RE: Couple of questions/thoughts about mcnett flats Subject: Date: Monday, February 22, 2021 10:02:05 AM Attachments: Existing vs. proposed Pius Way improvements.pdf image003.pnq

The attached was included in the Governing Body Review folder for this subdivision. I don't know why they didn't show these improvements into the other maps and exhibits for this subdivision? It shows the 10' trail on the north side of Pius with a 7' boulevard.

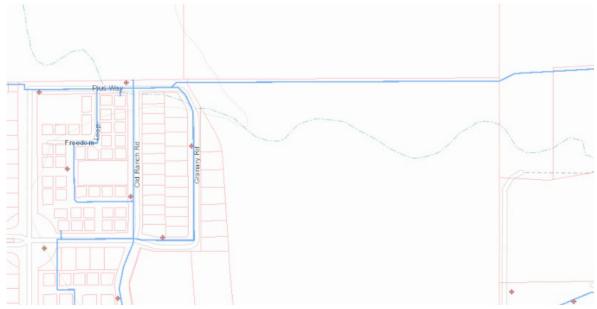
The below image shows we have an existing water main east of the Pius Way ROW. I would hope that we could work with the property owner(s) and be able to run a future trail within the existing water main easement as this land is already encumbered by the water main and associated easement.

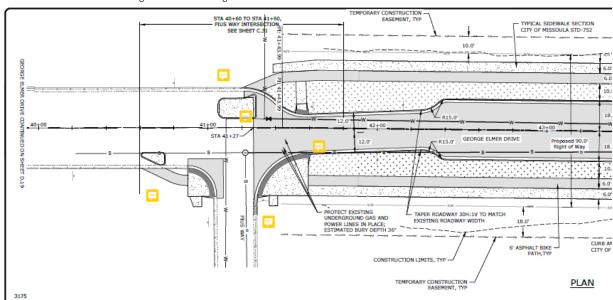
In addition, in the image below, which is a 90% BUILD Grant submittal, there is a buffered bike lane on the east side of GED in the existing section of the street (between 44 Ranch and Flynn Ranch) but in the area of Mcnett Flats the buffered bike lane is replaced by a separate offstreet bike lane. In the below image North is to the right.
